REMARKS

Prosecution on the merits has been closed under the doctrine of *Ex Parte Quayle*. No changes have been made in claims 1 and 2 except for changes necessary to remove various informalities, especially errors in the equations presented in claim 2.

**APPENDIX SHOWING THE CHANGES IN THE CLAIMS, ABSTRACT
AND SPECIFICATION**

FIG. 4

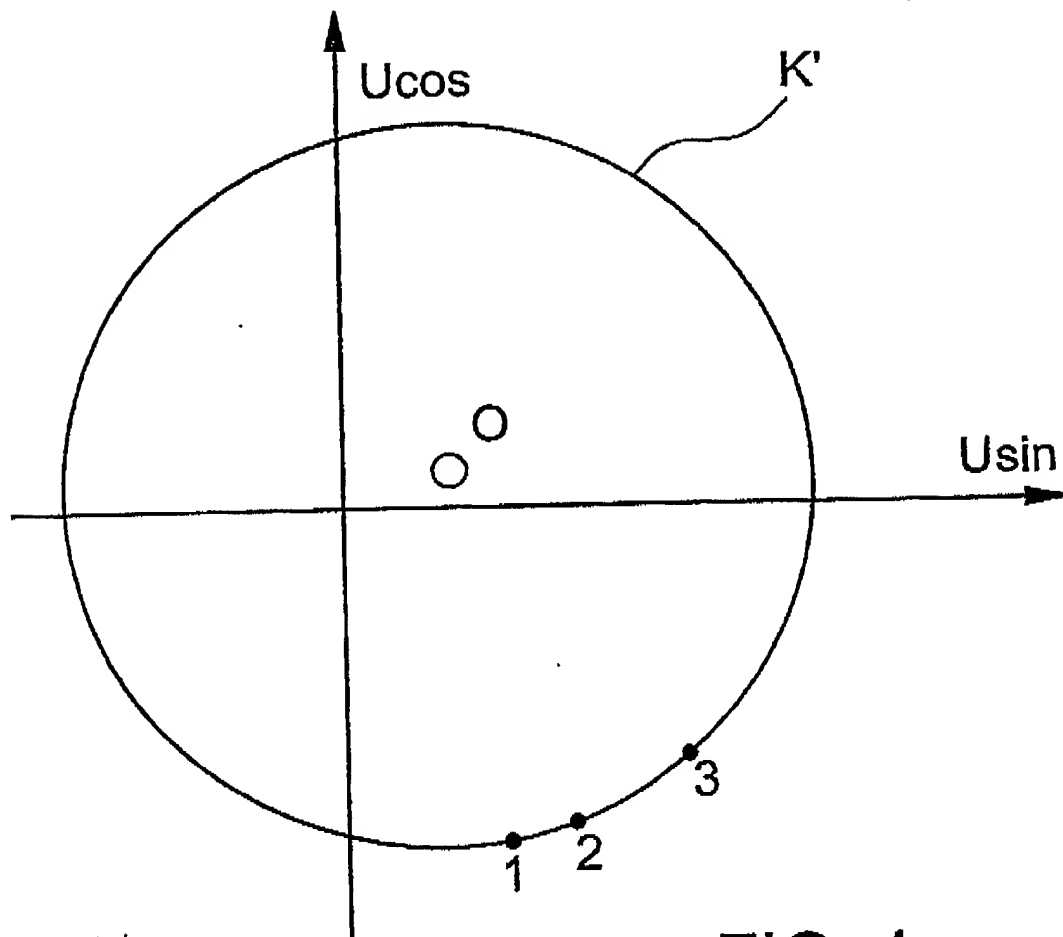
A sketch showing the suggested change in Fig. 4 has been attached to this amendment. The suggested change is shown in RED. Approval of the change, which amounts to translation of a German word into English, is respectfully requested.

Value Pairs:
~~Wertepaare:~~
 $U\sin(1), U\cos(1)$
 $U\sin(2), U\cos(2)$
 $U\sin(3), U\cos(3)$
